May 10, 2022

**Re: Response to Region of Waterloo Comments  
Zone Change Application Z-22-02, HIP Post LP**

Figure 1: Predicted Stationary Noise Impact at Proposed Development, Daytime/Evening (07:00 - 23:00)  
 Leq [dBA]

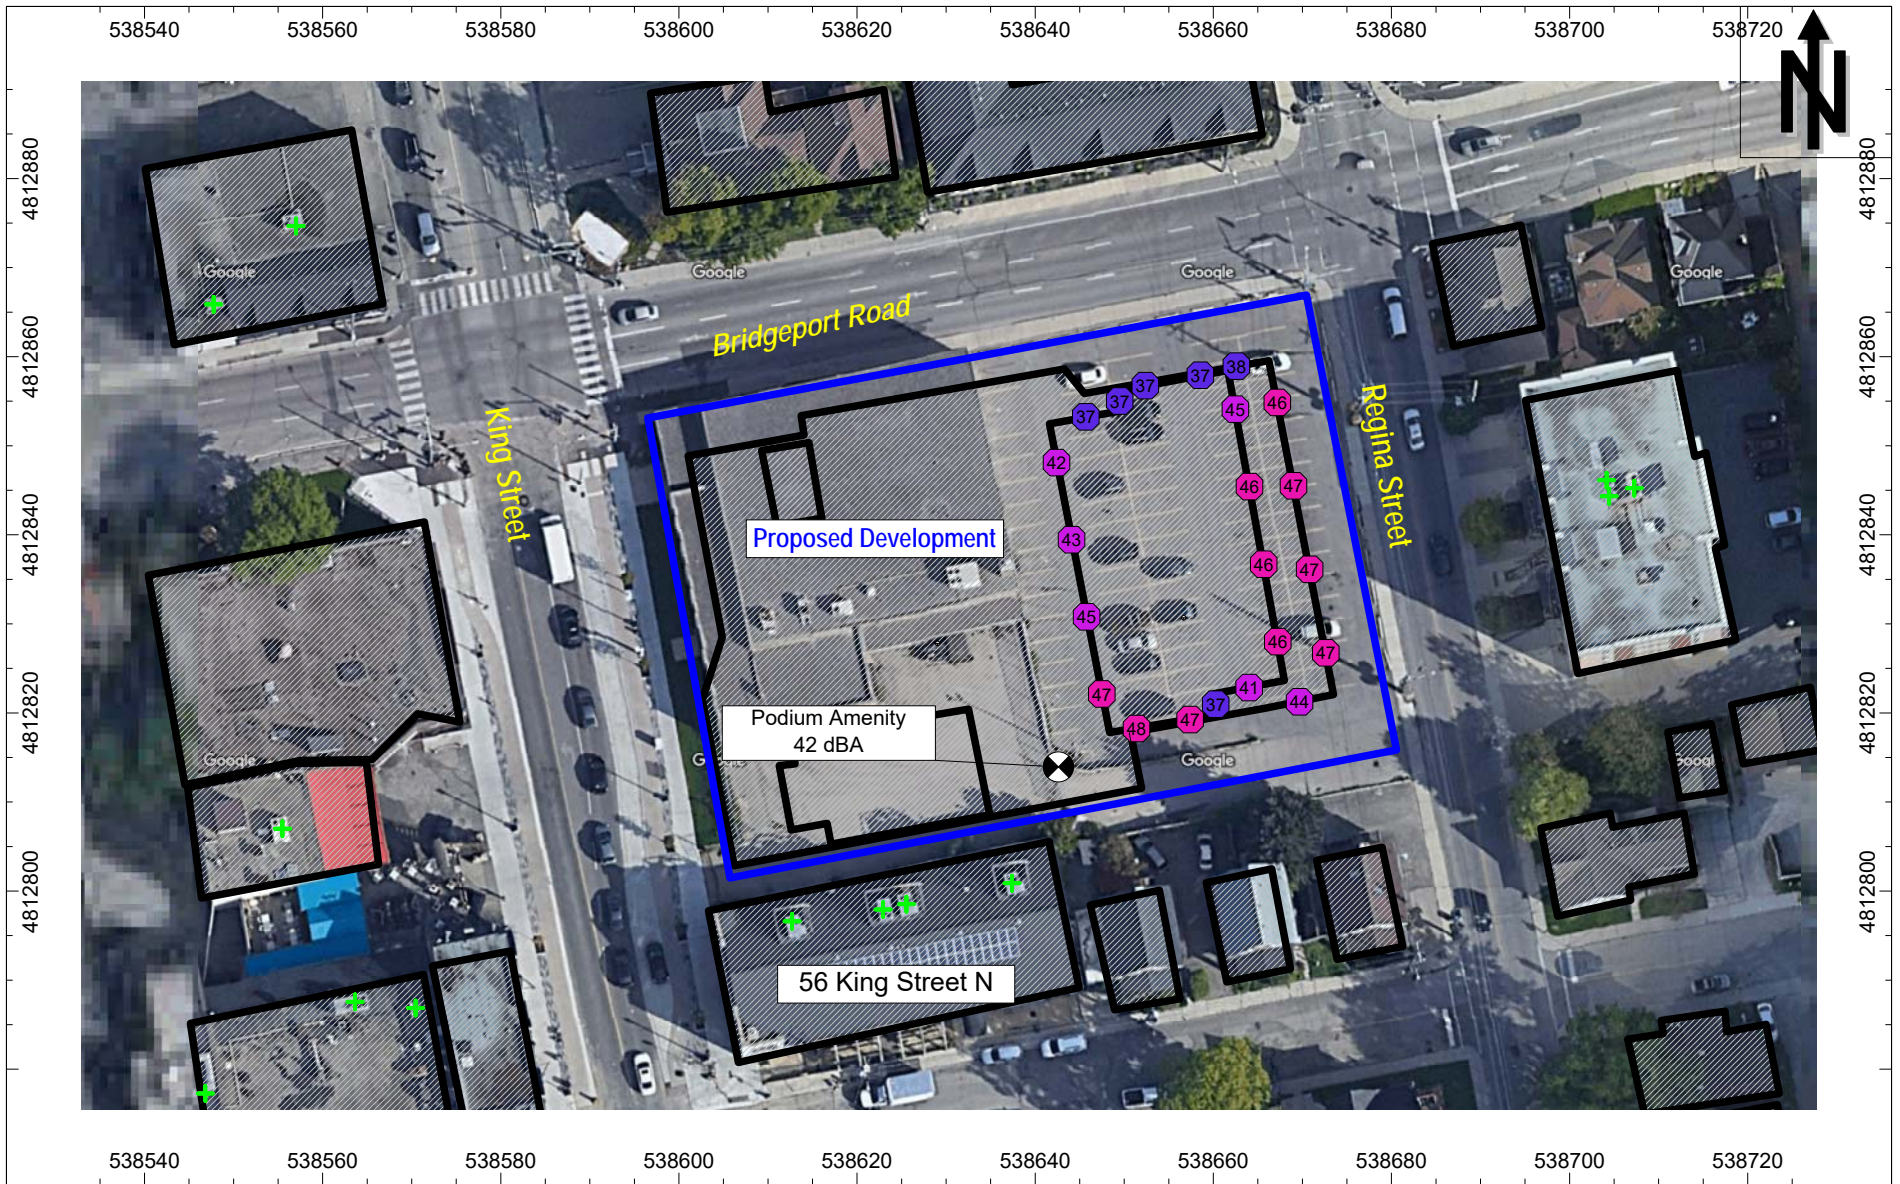
*“Regional staff notes that the adjacent building to the south at 56 King Street North includes at least four rooftop mechanical units. The noise consultant should confirm whether sound levels from these units have been considered and assessed on the proposed residential units facing the mechanical units. This information should be provided as part of the stationary noise assessment.”*

Figures 1 and 2, attached, show the highest sound level at the proposed façades across all residential floors and on the podium outdoor amenity area during the daytime and nighttime, respectively. Locations of the existing stationary noise sources are also shown as green crosses. We note that the building structure closest to 56 King Street North is the podium that is used for parking and commercial spaces. The closest proposed residential units are located in the high-rise residential tower on top of the podium level, and located in the east side of the podium. The numbers in octagons in Figures 1 and 2 are the predicted sound levels at the façades containing residential units.

The results show that sound levels at the residential windows of the proposed development can be up to 48 dBA during the daytime/evening and 45 during the nighttime at the residential façades, and up to 42 dBA during the daytime/evening at the podium amenity area. These levels are within the MECP's limits. Additional mitigation is not required.
